CONSIDERATION OF AND/OR ANY APPROPRIATE ACTION ON PANORAMA STREET PRELIMINARY PLAT, SITUATED IN THE PHILLIP ANDERSON SURVEY, ABSTRACT NO. 10 CITY OF PARKER, COLLIN COUNTY, TEXAS. [MACHADO]

Re: Panorama Street
 Preliminary Plat and Engineering Plan Review

As you requested, we have reviewed the Preliminary Plat & Engineering Plans for the Panorama Street Addition prepared by LJA Engineering, Inc. These documents include a new street and is therefore considered a major subdivision under section 155.025 of subdivision ordinance.

CITY OF PARKER
COLLIN COUNTY, TEXAS

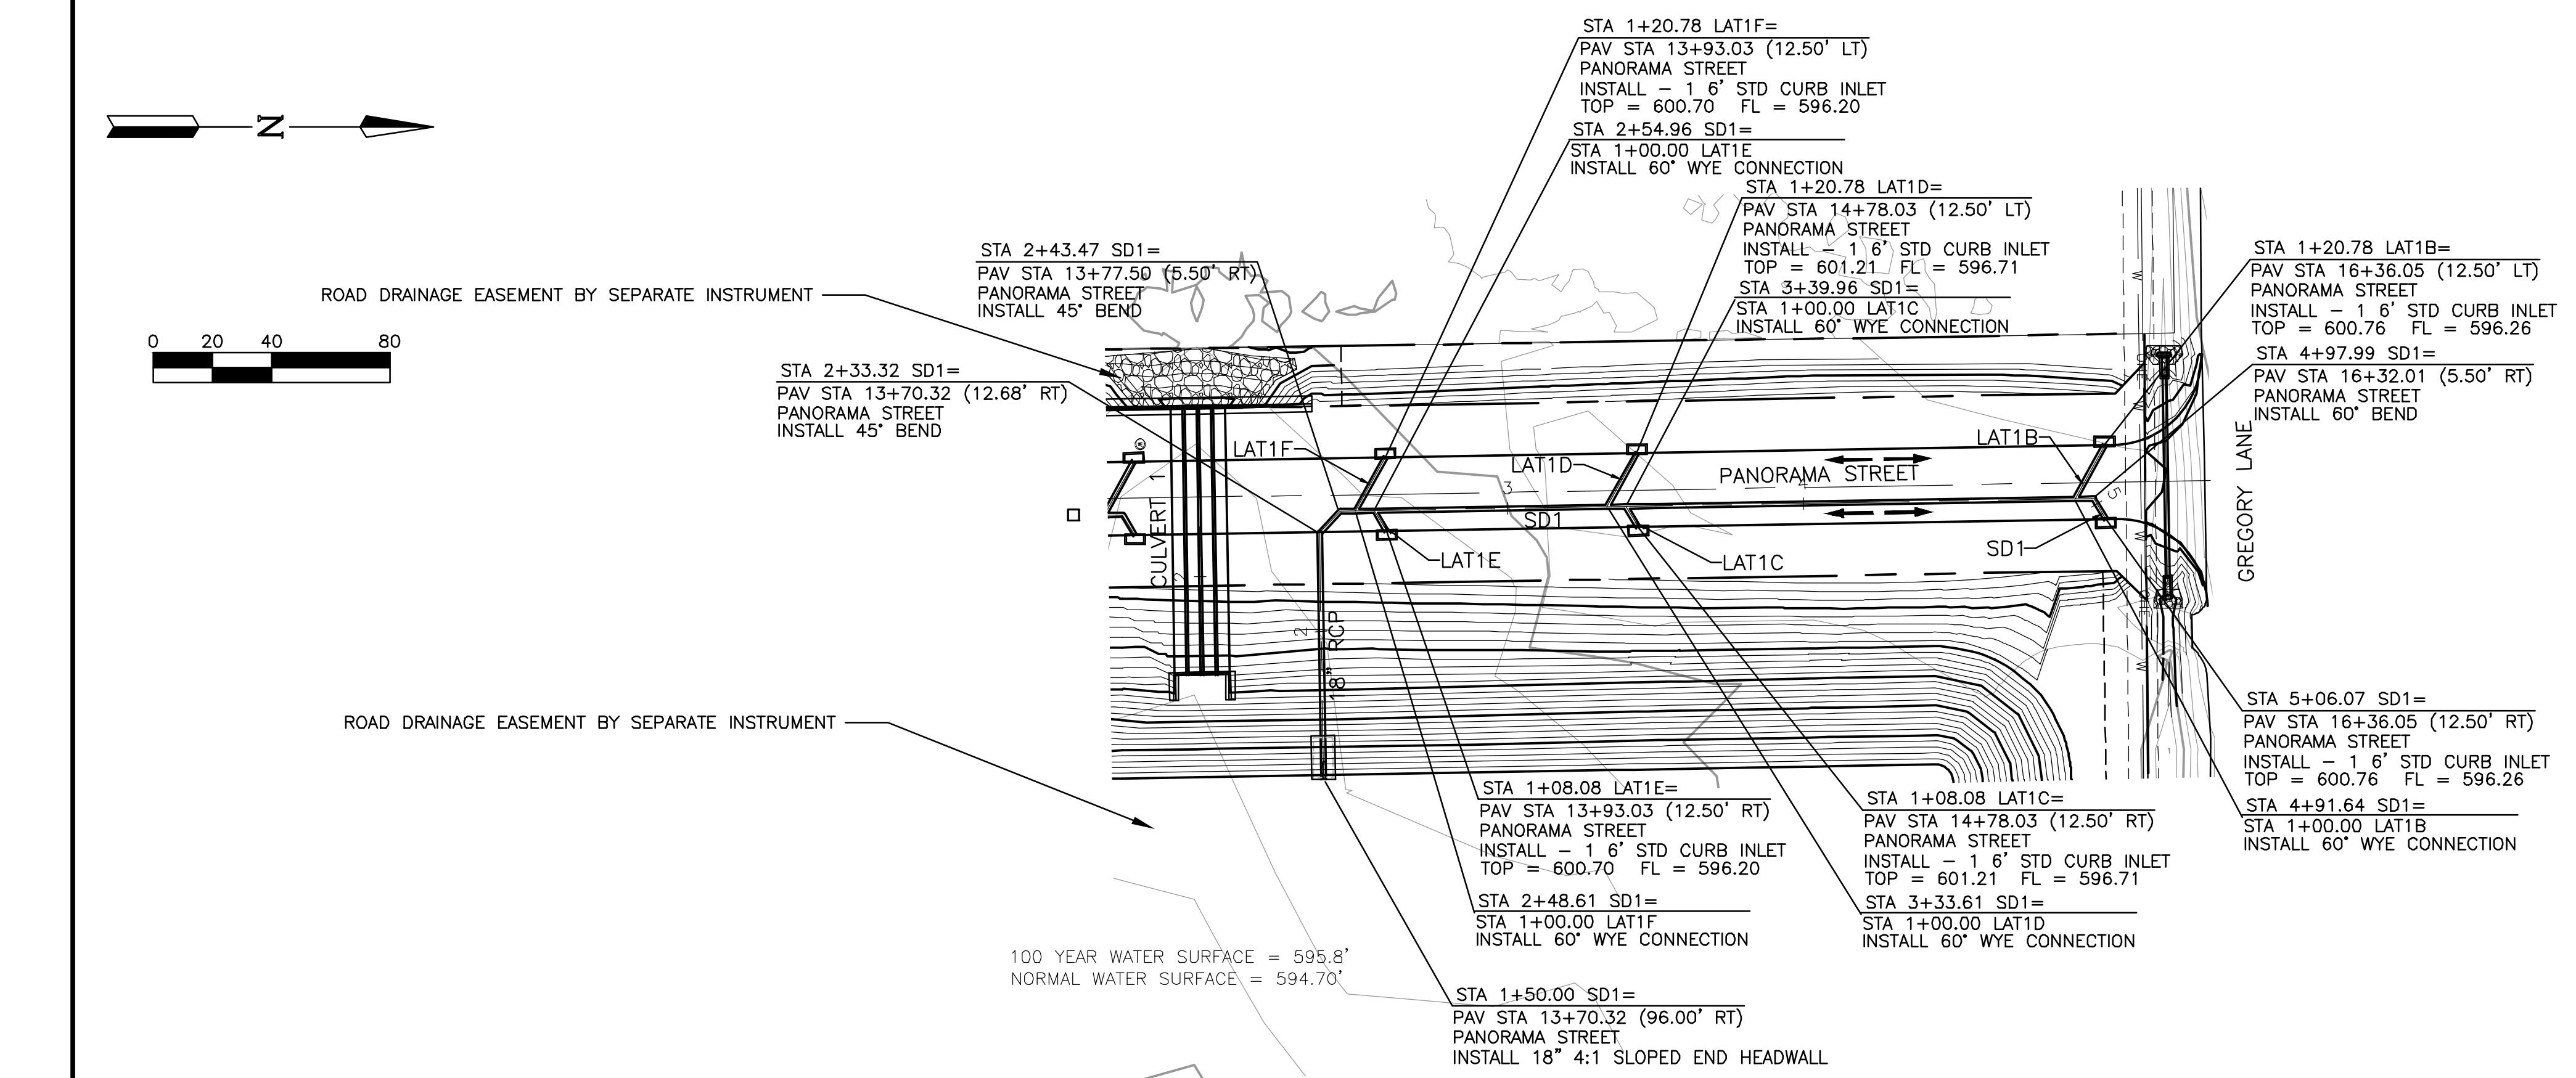
47. Sheet 20 Show depth of rip rap and geotextile fabric as foundation.
48. Sheet 20 Culvert 3 section does not correspond to what is called out in the plan view.

49. Sheet 20 Provide ASTM call out for RCP.
50. Sheet 20 Utilize radius pipe and eliminate bends.
51. Sheet 20 show footer at end of SD6.
52. Sheet 20 The call out in plan view for SD6 and Lateral 6B appear reversed to correspond with the section.

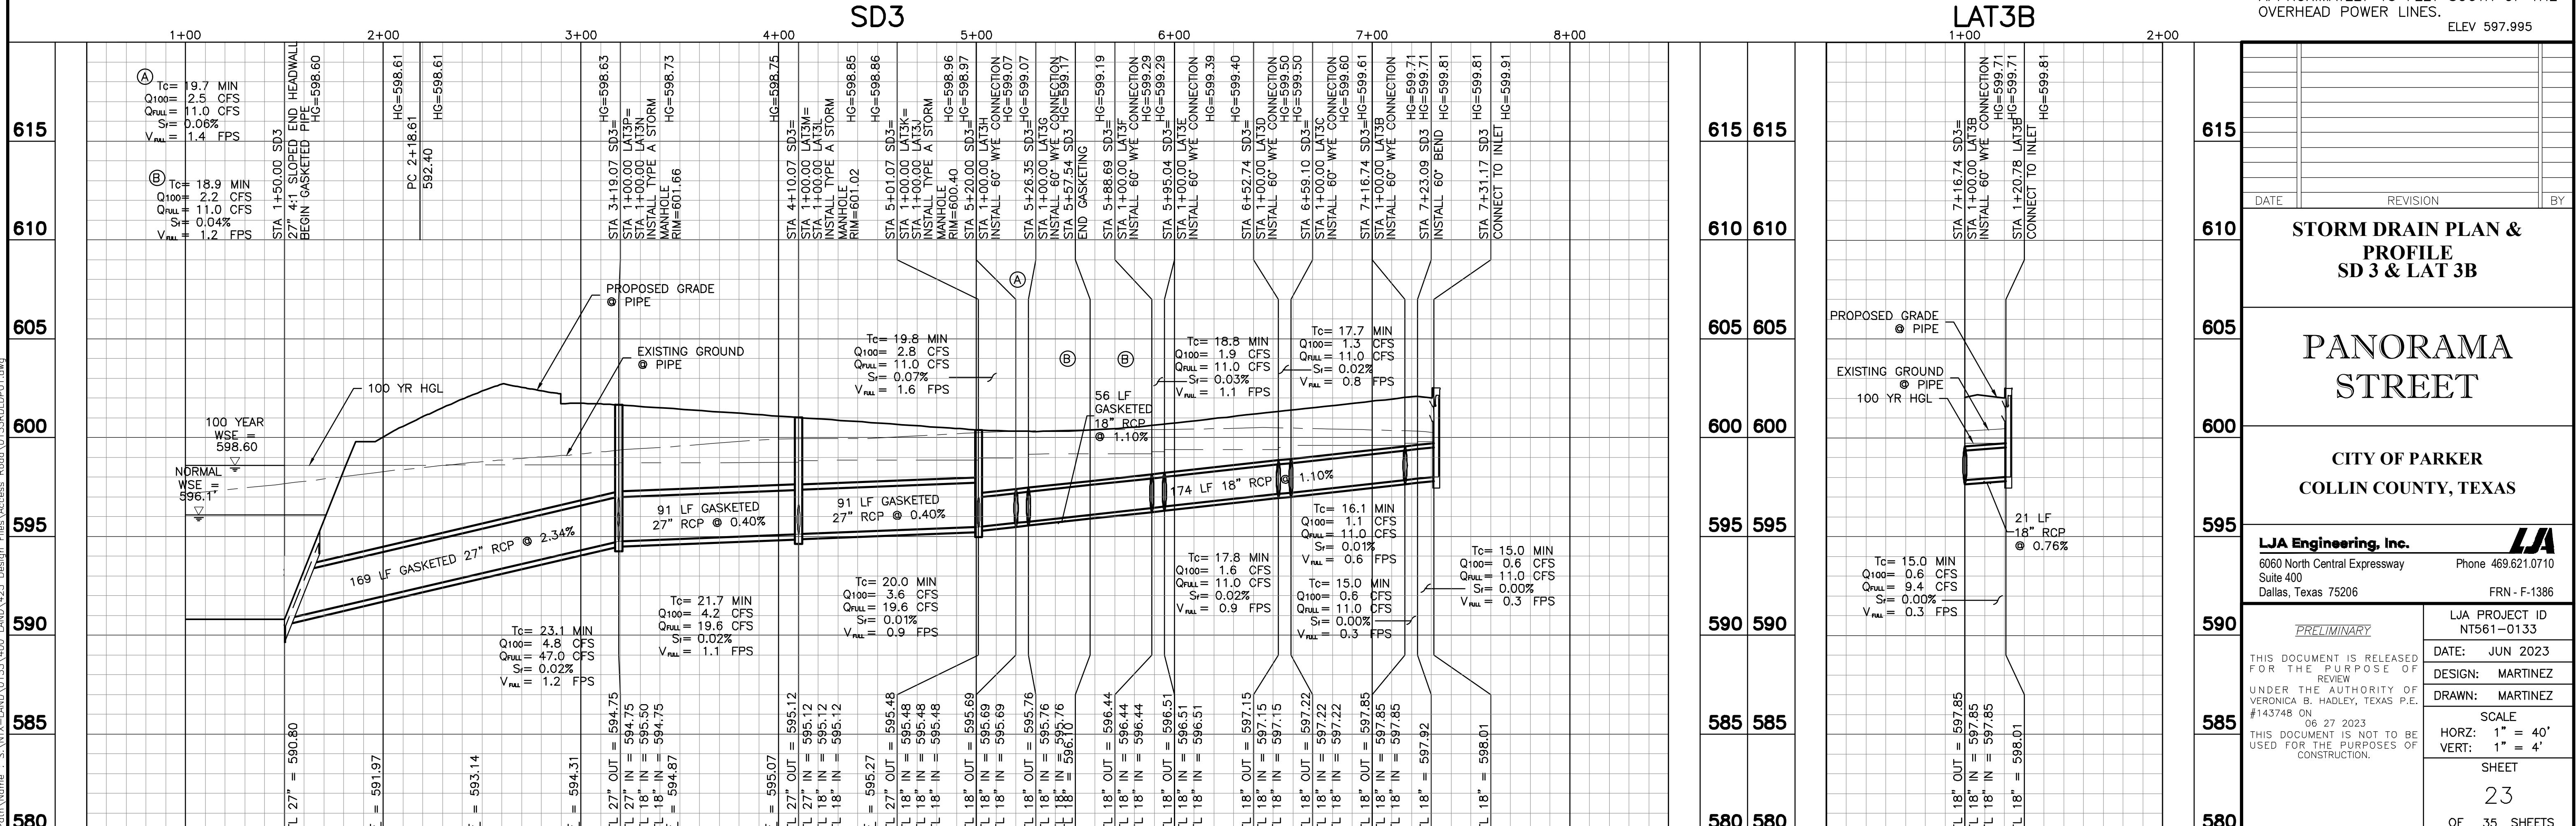
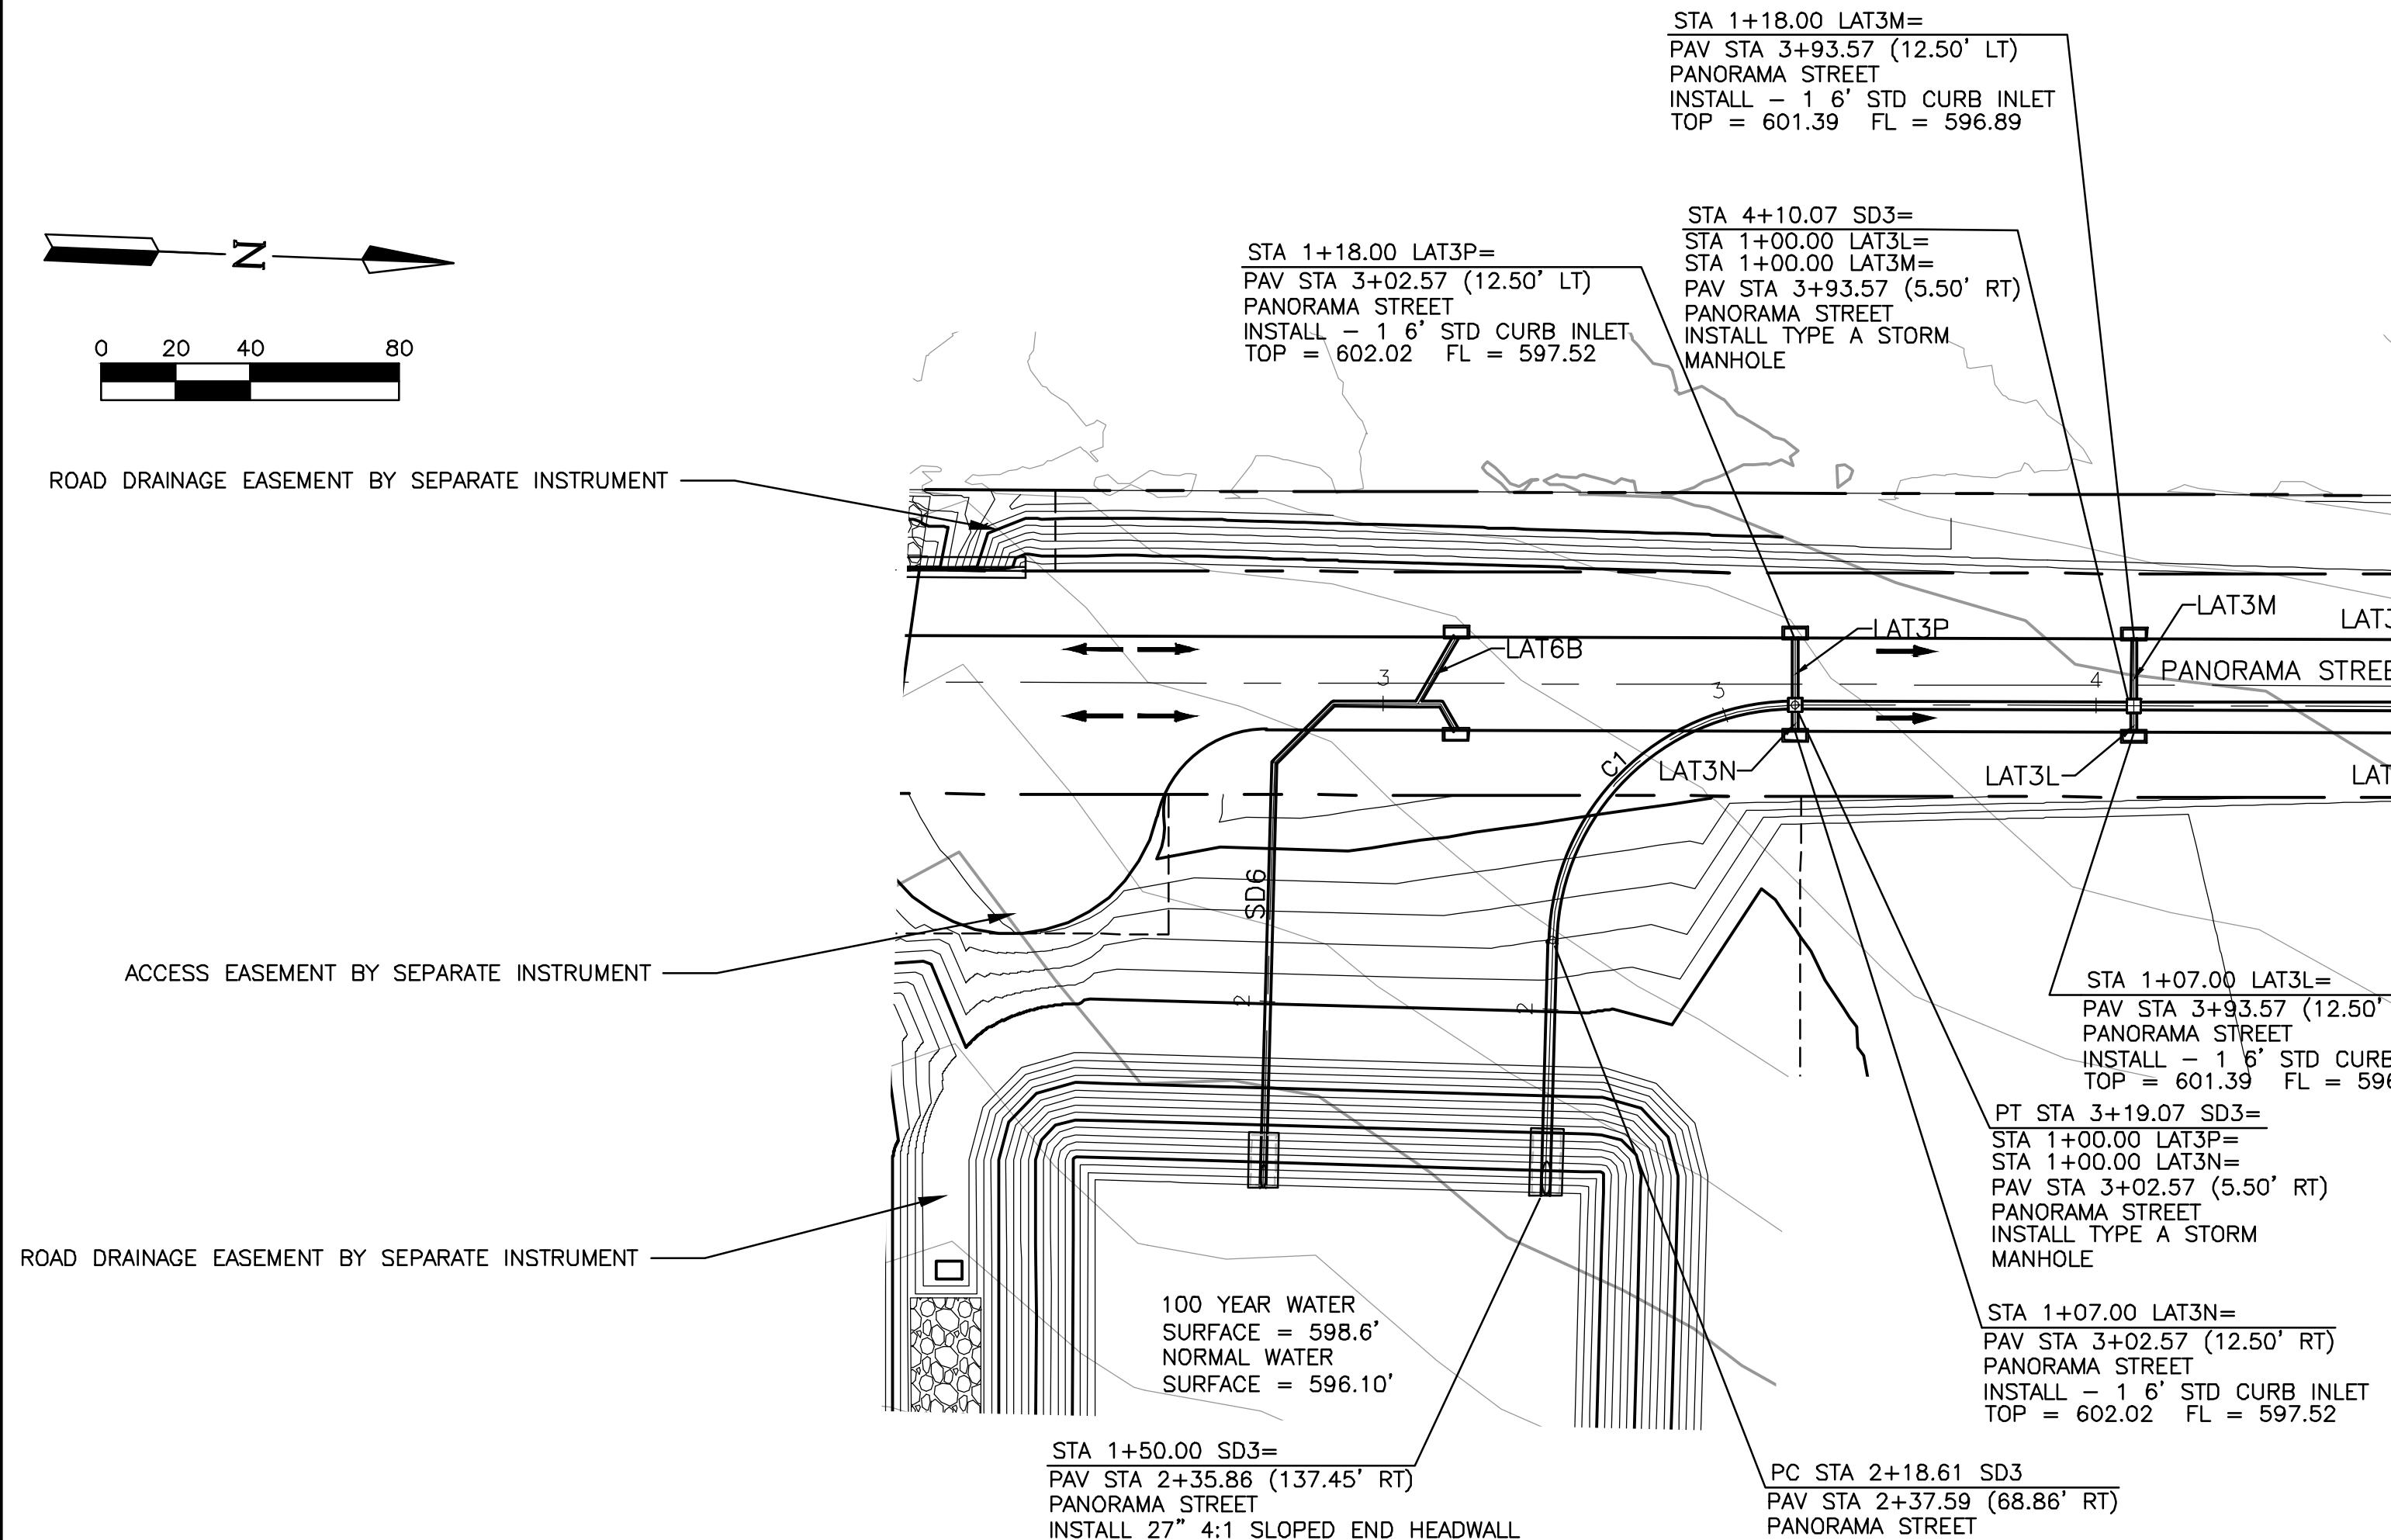
57. Sheet 22 Call out ASTM and Class of RCP pipe.
58. Sheet 22 Provide footers on headwalls.
59. Sheet 23 Call out ASTM and class of RCP pipe.
60. Sheet 23 Utilize radius pipe and eliminate bends.

61. Sheet 23 Utilize pipe wyes and not junction boxes for inlet laterals.
62. Sheet 24 SD4 reorientate to discharge normal to the flow of the channel it discharges into.
